A303 Sparkford to Ilchester Dualling Scheme TR010036

9.17 Deadline 4 – Supporting Information

Deadline 4 Supporting Information

Figure 1.1: Camel Hill SM in relation to the red line boundary and lateral limits of deviation

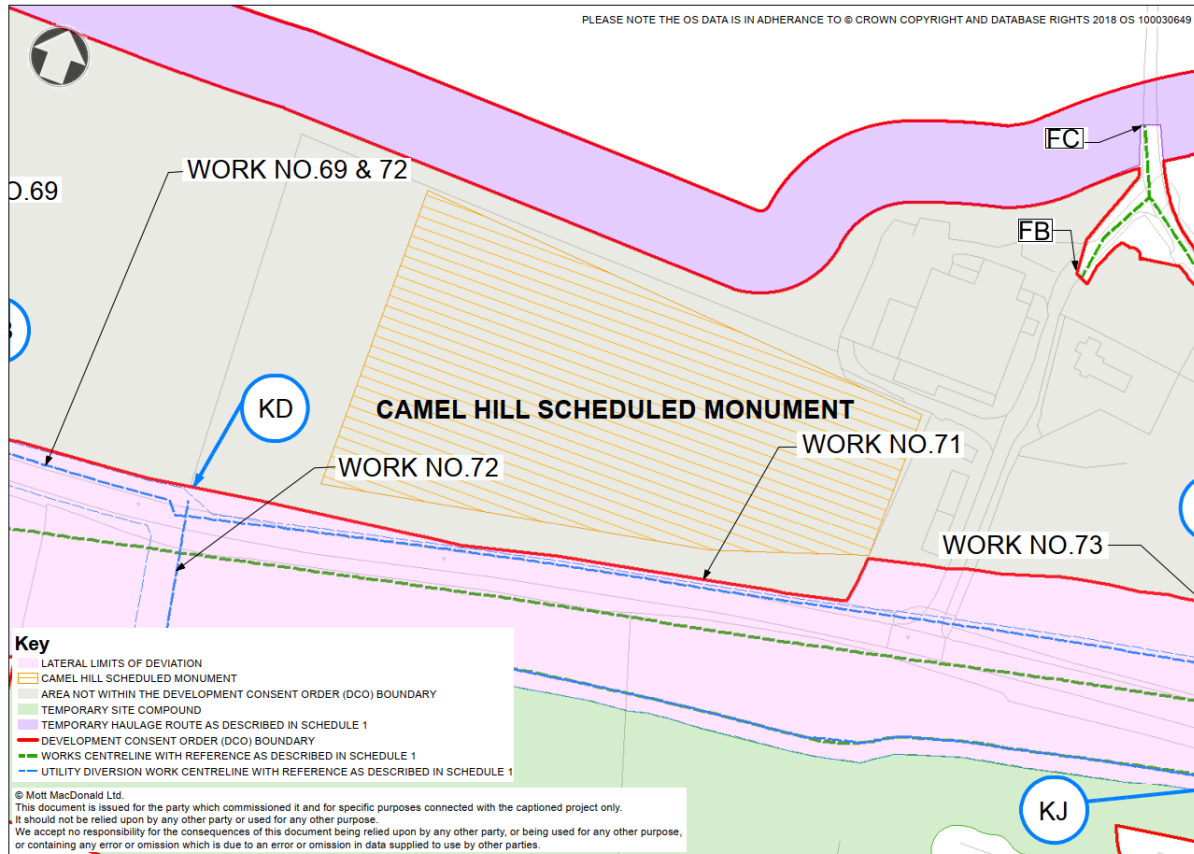
- 1.2.38 Action Point 14 requests: *Agree base position for Camel Hill SAM wirepoint drawing and larger scale drawing for clarity on Limits of Deviation including relevant written dimension.*

1.2.39 The base position for the Camel Hill Scheduled Monument (SM) wireframe drawing has been agreed with Historic England. The wireframe drawing is contained within Appendix A of this report.

1.2.40 Figure 1.1 below shows the Camel Hill SM in relation to the proposed red line boundary and the scheme Limits of Deviation.

Figure 2.1: Proposed main ecological mitigation areas

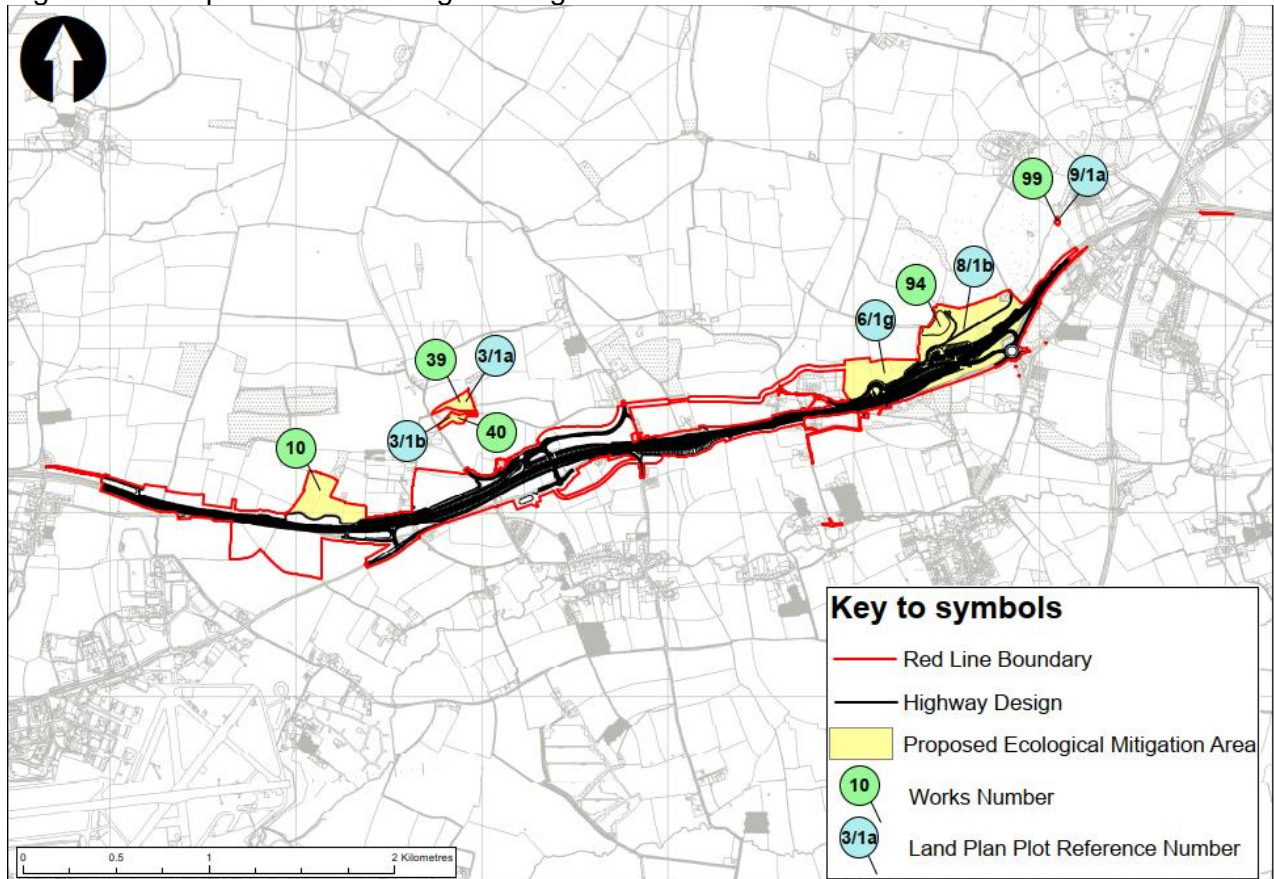
1.2.95 Action Point 40 requests: Provision of a schedule and plan setting out locations where permanent rights for maintenance of mitigation are required.

1.2.96 A schedule and plan setting out the locations where permanent acquisition of rights for maintenance of the main ecological mitigation areas are required is detailed in Table 1.1 and corresponding Figure 2.1 below.
